Access Compliance Report Public Rights-of-Way (Curb Ramps)

Intersection ID: 24230 Main Street: COMPTON_CT Cross Street: WITHAM_CT Location: SW

ADA ID: 5F2C8D43DD5D Ramp Type: PerpDiag Initial Pass/Fail: Fail Overall Compliance: No Severity Score: 8.75

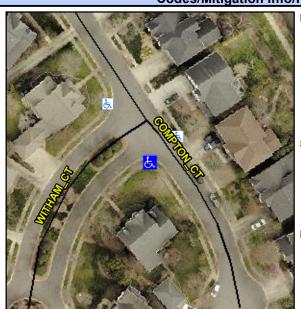
PROW/ADA:
Not Found, R304.5.1

Remove & Replace Curb Ramp With
Two New Directional Ramps or
Equivalent.
